# 6 SUB2006-00144

## **CHAMBLISS PROPERTIES EAST SUBDIVISION**

APPLICATION 1	NUMBER 6 DATE July 20, 2006 Chambliss Properties East Subdivision	
REQUEST	Subdivision	\
		NTS

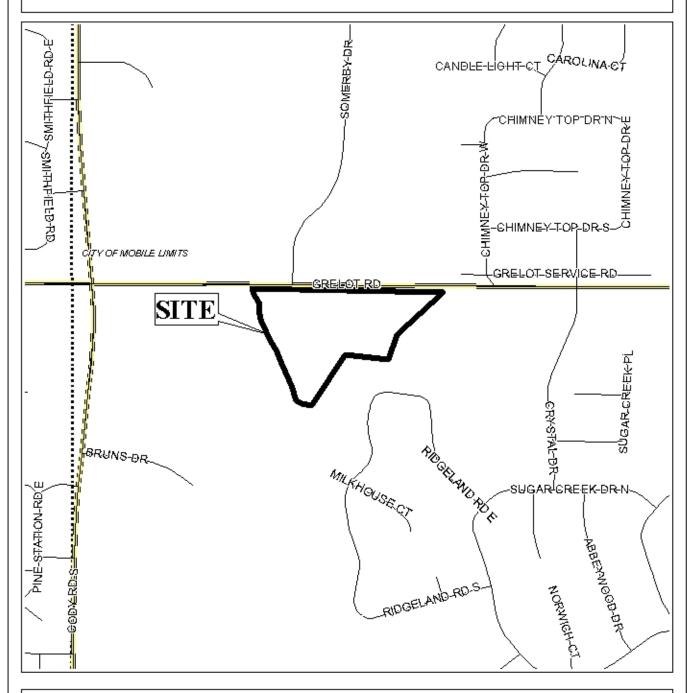
The plat illustrates the proposed 12.1± acre, 2-lot subdivision which is located on the South side of Grelot Road, 750'+ West of the South terminus of Chimney Top Drive West, and is in Council District 6. The site is served by public water and sanitary sewer.

As the site has extensive frontage, on a major street, Lot 1 should be limited to one curb-cut onto Grelot Road, and Lot 2 should be limited to two curb-cuts onto Grelot Road. The size, design and location of all curb-cuts must be approved by the Traffic Engineering Department.

As indicated on the Vicinity Map, Milkhouse Creek and significant wetlands are located on the site and as such the area may be environmentally sensitive; therefore, the approval of all applicable federal, state and local agencies would be required prior to the issuance of any permits.

The plat meets the minimum requirements of the Subdivision Regulations and is recommended for Tentative Approval, subject to the following conditions: 1) placement of a note on the Final Plat stating that Lot 1 is limited to one curb-cut onto Grelot Road, and Lot 2 is limited to two curb-cuts onto Grelot Road, with the size, design and location of all curb-cuts to be approved by the Traffic Engineering Department; and 2) the approval of all applicable federal, state and local agencies prior to the issuance of any permits.
